FINAL PLAT **SWBC Rockwall Addition, Phase 1** Lots 1, Block A 21.280 Acres

AGENDA ITEM: P2018-033; Final Plat: SWBC Rockwall Addition, Phase 1

Project Number P2018-033

Project Name Lot 1, Block A, SWBC Rockwall Addition,

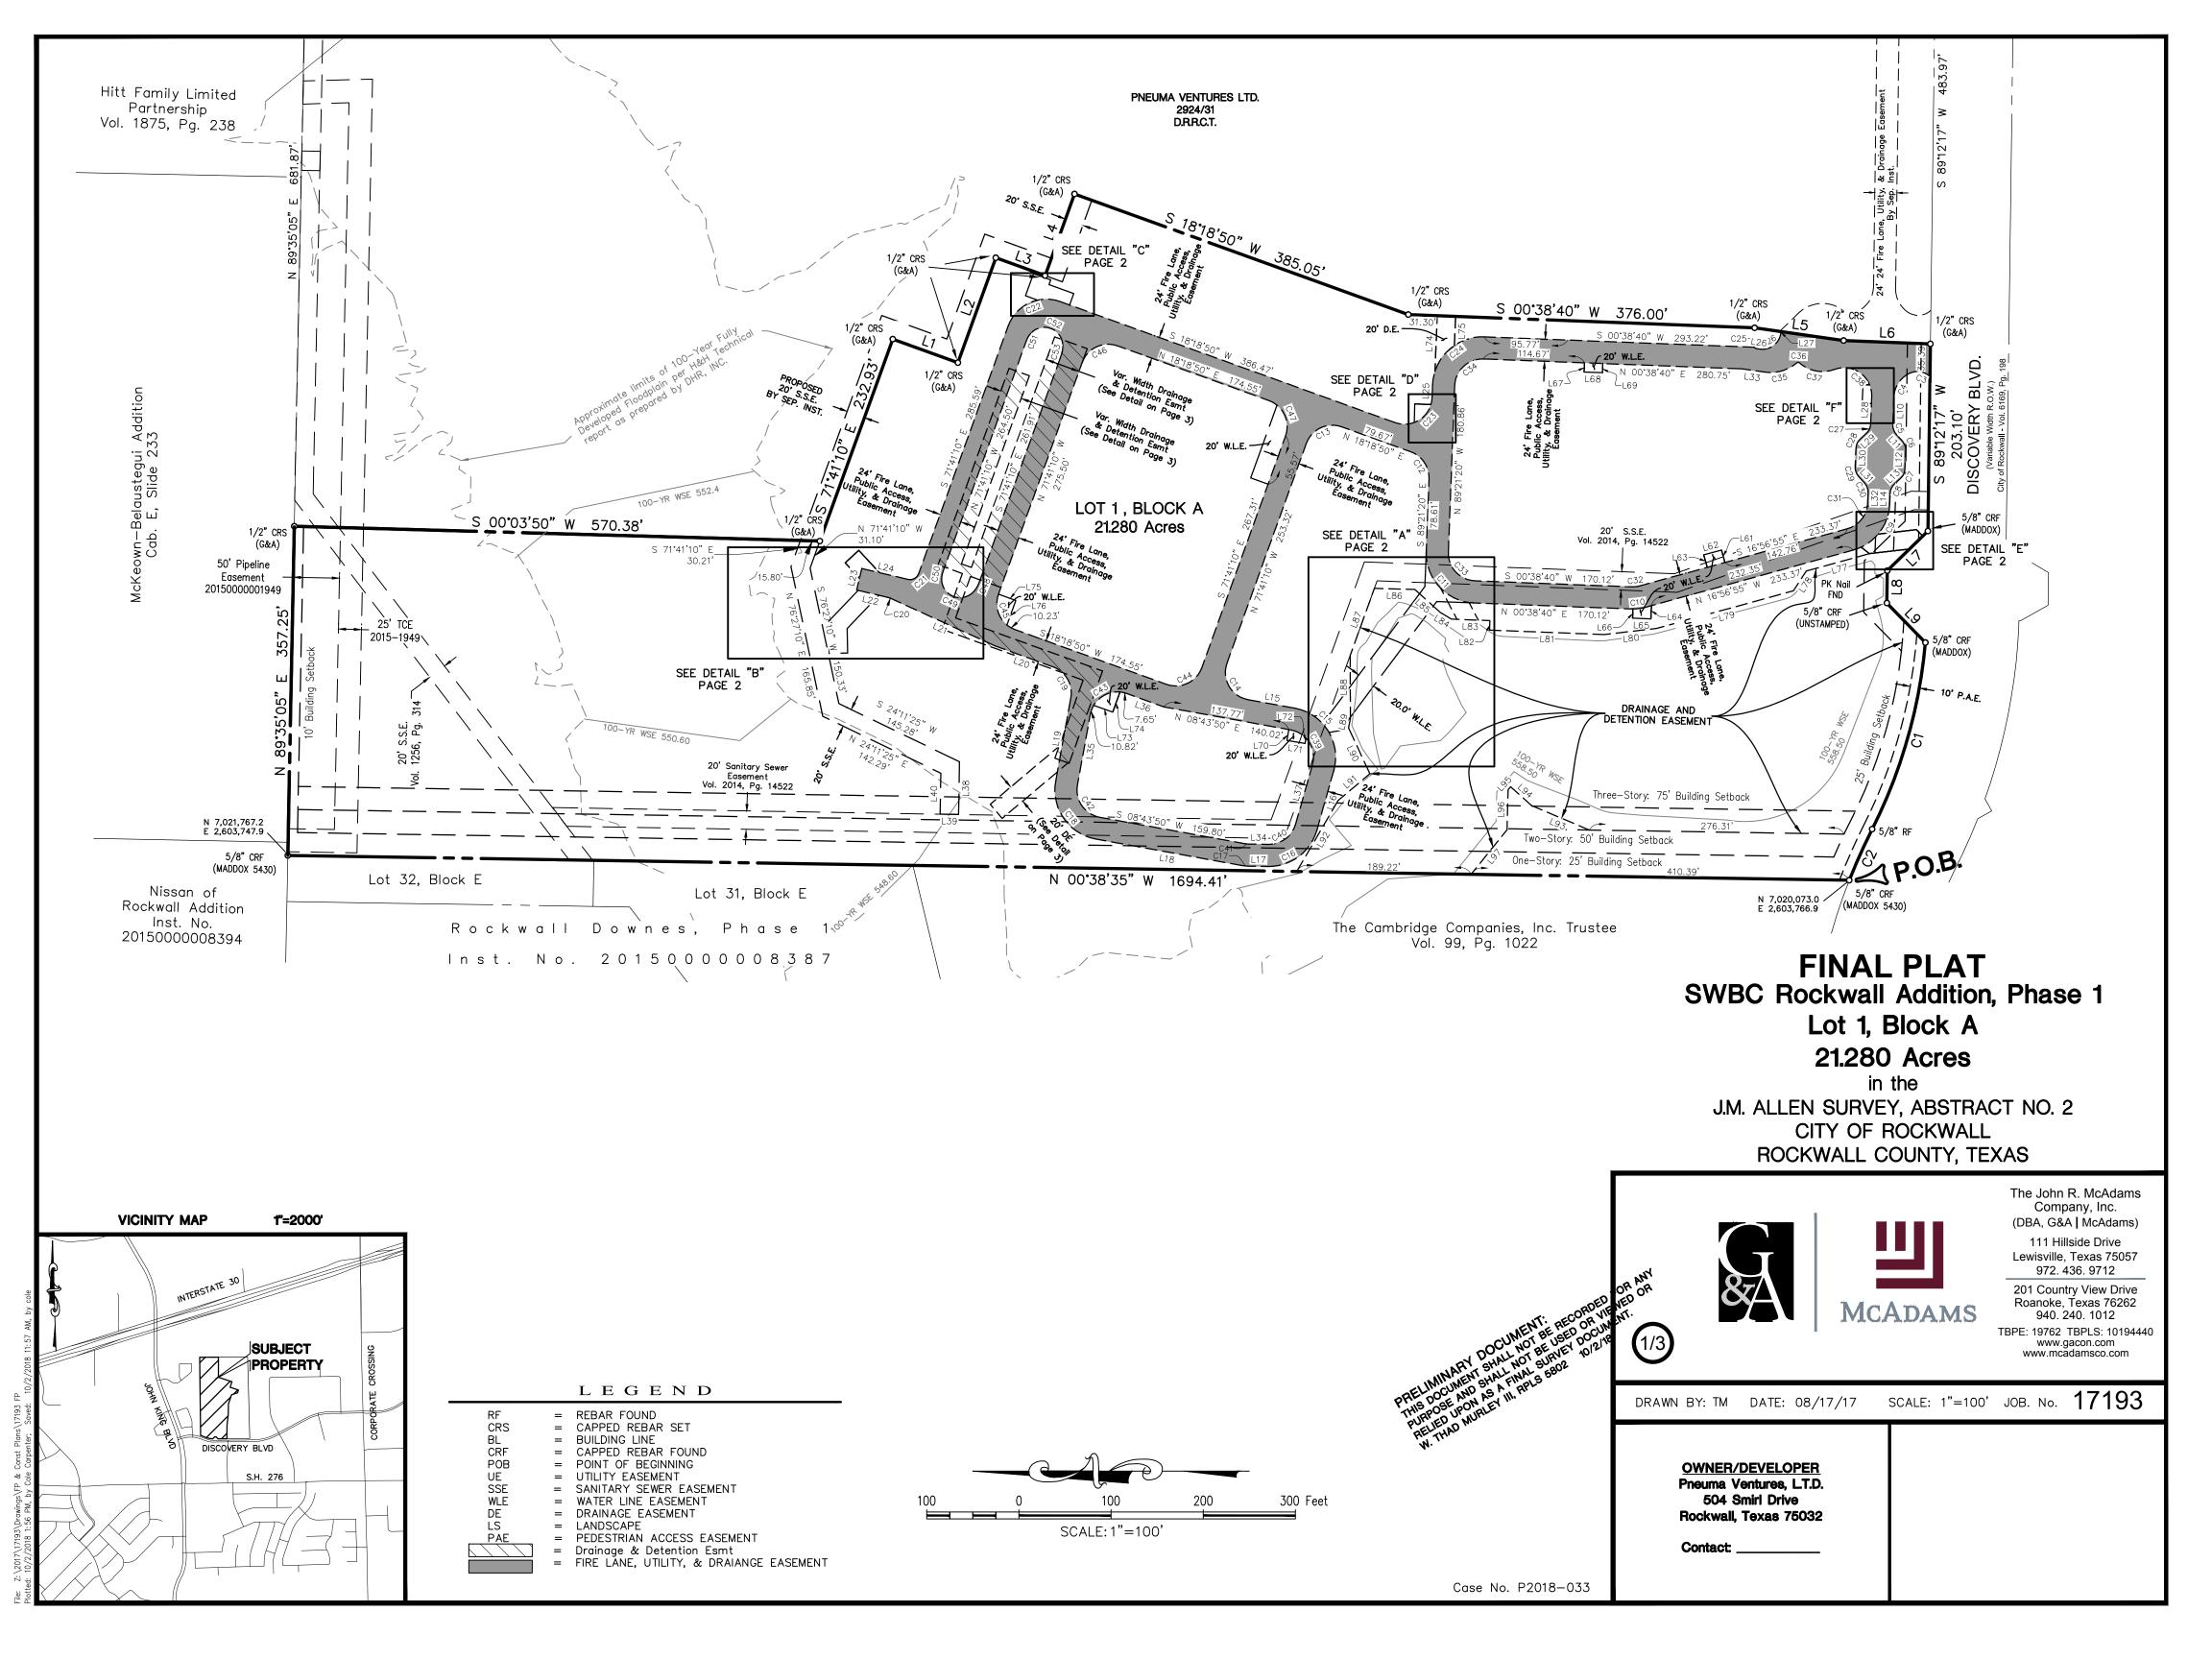
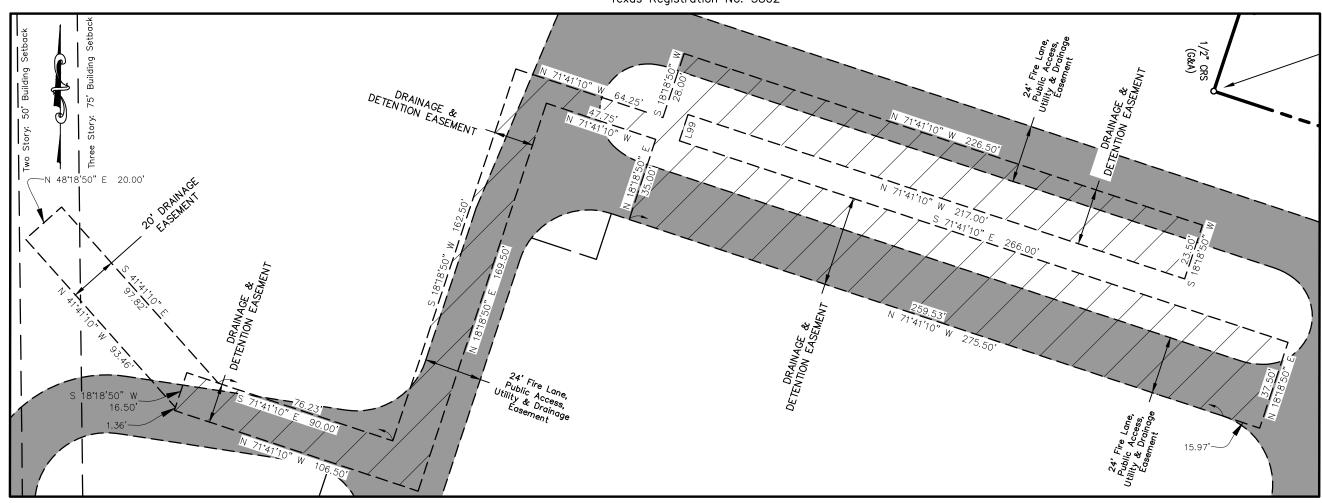
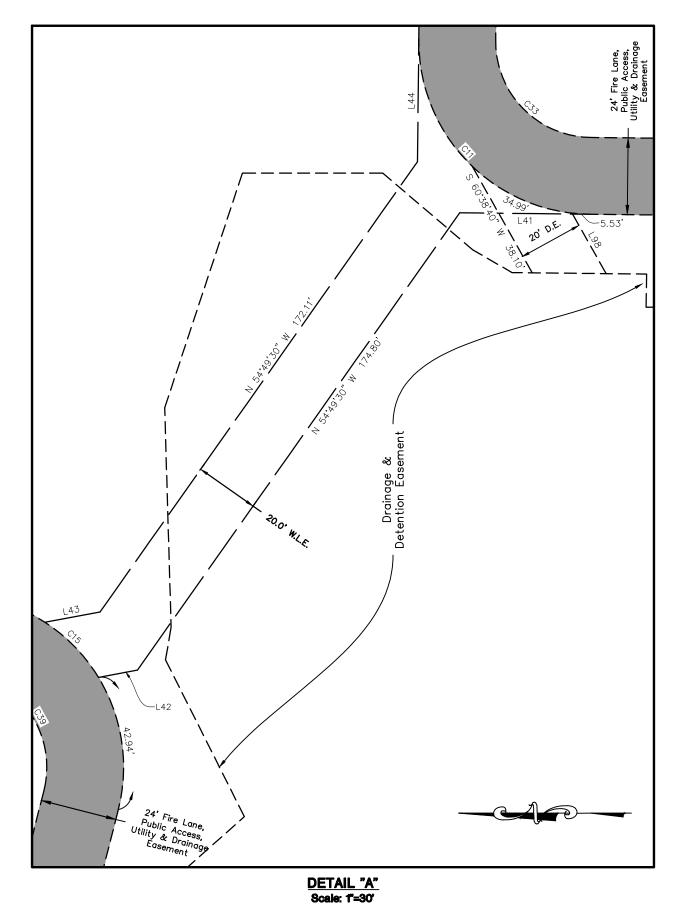
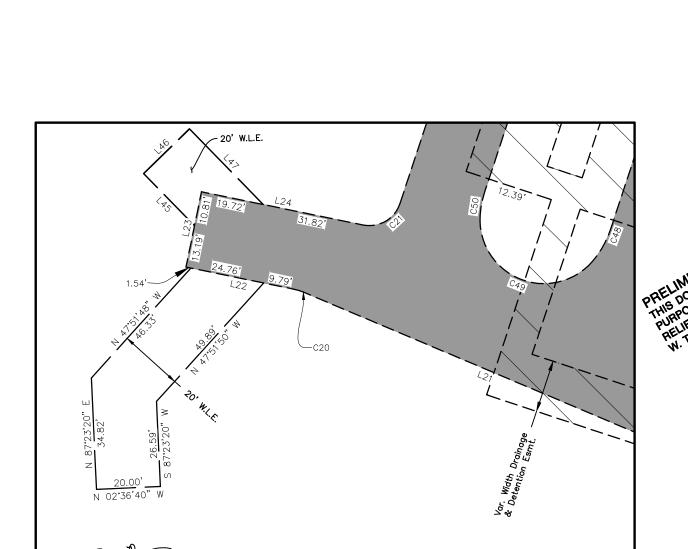
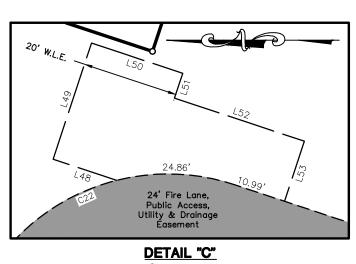
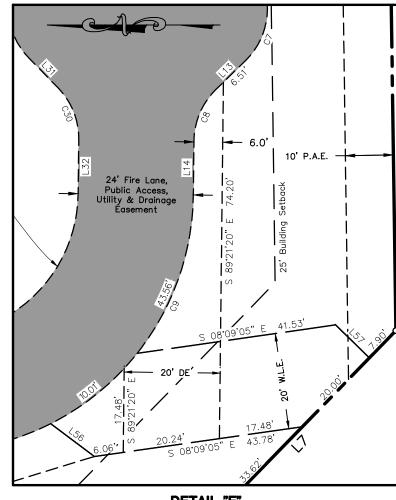
- Filing will not be allowed until Engineering Plans are Approved.
- Label all easements. Make sure text isn't overlapping. Need instrument Numbers now.
- Include a drainage easement for the detention outfall structure.
- Which Detail F is correct?
- Label the Fire Lane as "Fire Lane, Utility, and Drainage Easement"
- Include a sidewalk easement along Discovery.

- 2. Provide a label indicating "Case No. P2018-033" on the lower right corner on all pages of the revised final plat submittal
- 3. Provide additional copy of plat that does not include call-outs for the access drives and the "details boxes".

- 4. Use a ligher gray scale for the 100-yr flood plain.
- 5. Move the POB label outside of the plat boundary.
- 6. Move the Northing and Easting calls outside of the plat boundary, located below the POB on the lower right corner.

- 7. Provide a label and hatch the firelane, including the witdth (i.e. 24-ft Firelane).
- 8. Relabel all Mutual Access as "Public Access" and include firelane, if appropriate [i.e. 24-ft Firelane, Public Access, Utility & Drainage Easement] and place in all legends.

- 9. Correct Title Block Should read "Lot 1, Block A".
- 10. Hardscape Plan indicate trail system as approved on Open Space Plan
